# UNITED STATES PATENT AND TRADEMARK OFFICE

APPLICATION NO.	FILING DATE	FIRST NAMED INVENTOR	ATTORNEY DOCKET NO.	CONFIRMATION NO.
10/823,469	04/13/2004	Sanjeev M. Naik	GP-303757	4574

<b>Office Action Summary</b>	<b>Application No.</b> 10/823,469	<b>Applicant(s)</b> NAIK ET AL.	
	<b>Examiner</b> Lan Nguyen	<b>Art Unit</b> 3683

**PRIOR ART**  
**FIG. 1**

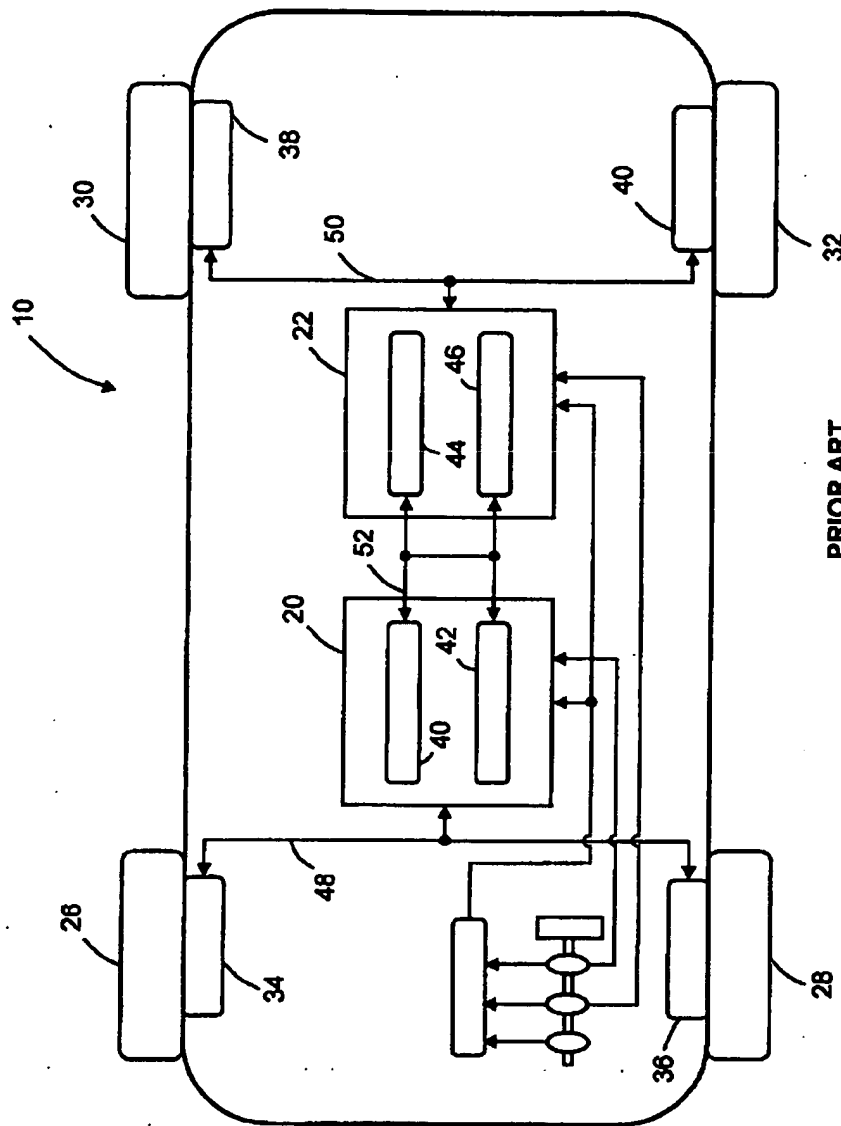
3. Claims 1-12, 14, 17 and 20-22 are rejected under 35 U.S.C. 103(a) as being unpatentable over Applicant's admitted Prior Art of Figure 1 in view of Kato et al. (USP 5,548,601).

Re: claim 1, Figure 1 of the admitted Prior Art teaches a brake control system, as in the present invention, comprising: a first pair of brake control units 34, 36; a second pair of brake control units 38, 40; a first brake control bus 48 which is operatively connected to each of the respective ones of said first pair of brake control units; a second brake control bus 50 which is operatively connected to each of the respective ones of said second pair of brake control units; a first supervisor controller 20 which is operatively connected to said first brake control bus and adapted to control each of the respective ones of said first brake control unit pair through said first control bus; a second supervisory controller 22 which is operatively connected to said second brake

Re: claim 14, Figure 1 of the admitted Prior Art shows a brake control system, comprising: a first pair of brake control units 34, 36, a second pair of brake control units 38, 40, a first brake control bus 48 which is operatively connected to each of the respective ones of said first pair of brake control units, a second brake control bus 50 which is operatively connected to each of the respective ones of said second pair of brake control units; a first supervisory controller 20 which is operatively connected to said first brake control bus and adapted to control each of the respective ones of said first brake control unit pair through said first control bus; a second supervisory controller 22 which is operatively connected to said second brake control bus and adapted to control each of the respective ones of said second brake control unit pair through said second control bus; a controller bus 52 which is operatively connected to each of said first supervisory controller and said second supervisory controller; and the first and second supervisory controllers each signally connected to a brake actuation module as marked in figure 1 above. Figure 1 of the admitted Prior Art lacks the monitoring controller and a cut off module as claimed. Kato et al. teach a monitoring controller 80, 85 which is operatively connected to said controller bus and adapted to monitor the performance of said first supervisory controller, said second supervisory controller, said first brake control bus, and said second brake control bus; and a brake control cutoff

5. Applicant's arguments filed 11/30/05 have been fully considered but they are not persuasive. Applicant argues that the admitted Prior Art of Figure 1 and Kato et al. do not teach or suggest the amended portion of claims 1, 14 and 17. Admitted Prior Art of Figure 1 and Kato et al. do teach the first and second supervisory controllers and the monitoring controller each signally connected to a brake actuator module as stated in the rejection above.
